REMARKSSpecification Amendments

The Drawing Amendments

**Fig. 1**  
PRIOR ART

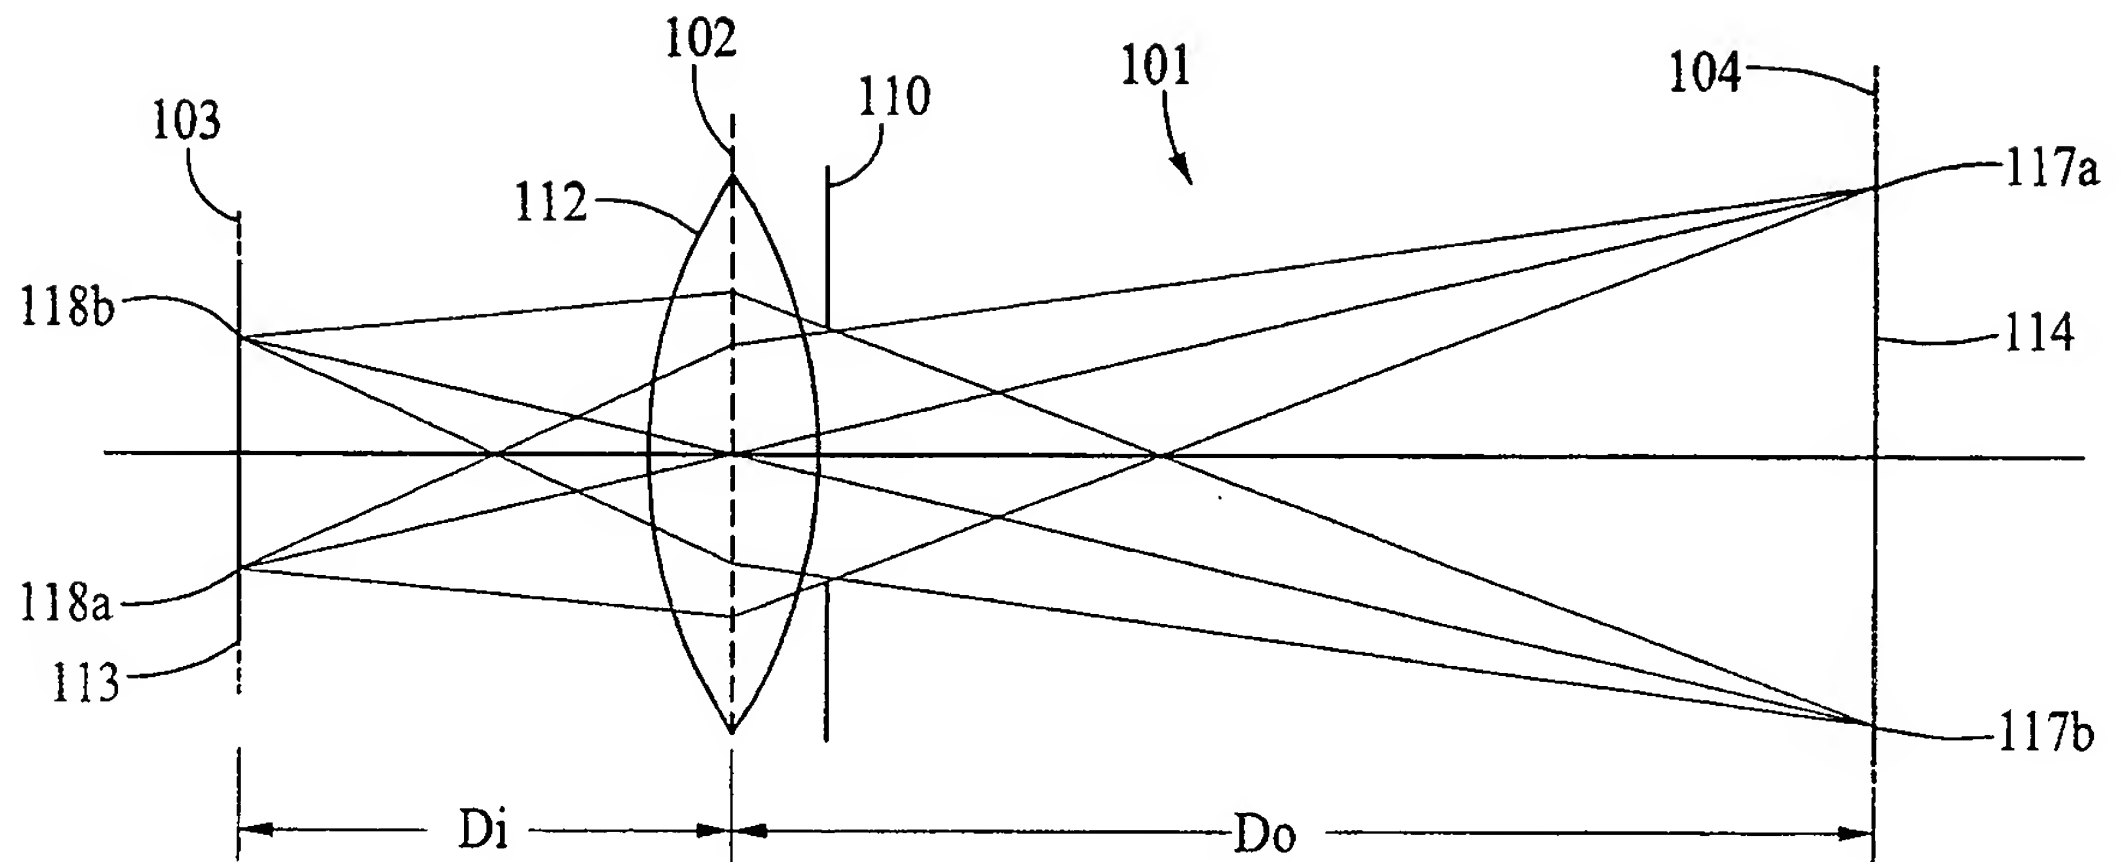
In each of Figs. 1-3 the notation "PRIOR ART" is added below the figure number. This same amendment was made in the parent to the present application as required by the Examiner therein. These amendments are included in the set of formal drawings filed concurrently herewith.
